# Access Compliance Report

## Public Rights-of-Way

Intersection ID: 11597	Main Street: E_20TH_ST	Cross Street: SEIGLE_AV	Location: W
ADA ID: 98CB09A199B0	Ramp Type: BlendTrans2	Initial Pass/Fail: Fail	Overall Compliance: No
		Severity Score: 8.75	
Codes/Mitigation Info/Possible Solution		Field Measurements/Component Compliance

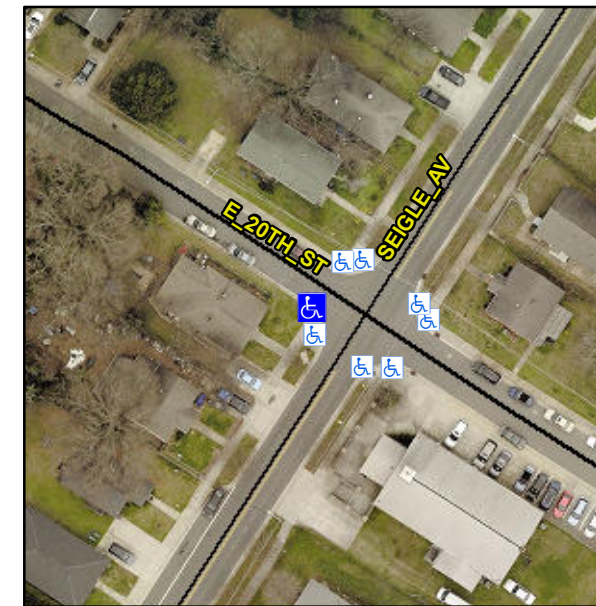
**CURB LIP 0.5**

**Not Found, R304.5.1**

Compliance	Description	Data	Compliance	Description	Data
N/A	Ramp Length (in)	60.5	Yes	BlendTrans Slope (%)	3.3
No	Ramp Width (in)	47.5	Yes	BlendTrans XSlope (%)	2.0
N/A	Flare Type LT	N/A	N/A	Flare Type RT	N/A
N/A	Flare Slope LT (%)	N/A	N/A	Flare Slope RT (%)	N/A
N/A	Flare Traversable LT?	N/A	N/A	Flare Traversable RT?	N/A
N/A	Landing Length (in)	N/A	N/A	DWS Provided?	N/A
N/A	Landing Width (in)	N/A	N/A	DWS Contrast?	N/A
N/A	Landing Slope (%)	N/A	N/A	DWS Length (in)	N/A
N/A	Landing X Slope (%)	N/A	N/A	DWS Full Width?	N/A
N/A	Landing Curb? (Y/N)	N/A	N/A	DWS Offset (in)	N/A
N/A	Shared Landing?	N/A			
N/A	Gutter Ponding?	N/A	N/A	Gutter Slope (%)	N/A
N/A	Gutter Lip Ht (in)	N/A	N/A	Gutter X Slope (%)	N/A
N/A	Painted X Walk1?	No	N/A	Painted X Walk2?	N/A
	X Walk 1 Direction	To E		X Walk 2 Direction	N/A
	X Walk 1 Width (in)	N/A		X Walk 2 Width (in)	N/A
	X Walk 1 Slope (%)	8.9		X Walk 2 Slope (%)	N/A
	X Walk 1 X Slope (%)	4.0		X Walk 2 X Slope (%)	N/A

N/A	Ramp inside XWalk1?	N/A	N/A	Ramp inside XWalk2?	N/A
	Road Slope (%)	4.0		Clear Space?	N/A
	Road X Slope (%)	8.9	N/A	Clear Space to XWalk (in)	N/A
N/A	Any Obstructions?	N/A	N/A	Storm Grate/Utility Hazard?	N/A
	Obstruction Type			Storm Grate/Utility Type	
		N/A			N/A
			Yes	Surface Condition? (G/P)	Good
			No	Curb Slope (%)	6.0

**Remove & Replace Curb Ramp With Two New Directional Ramps or Equivalent.**
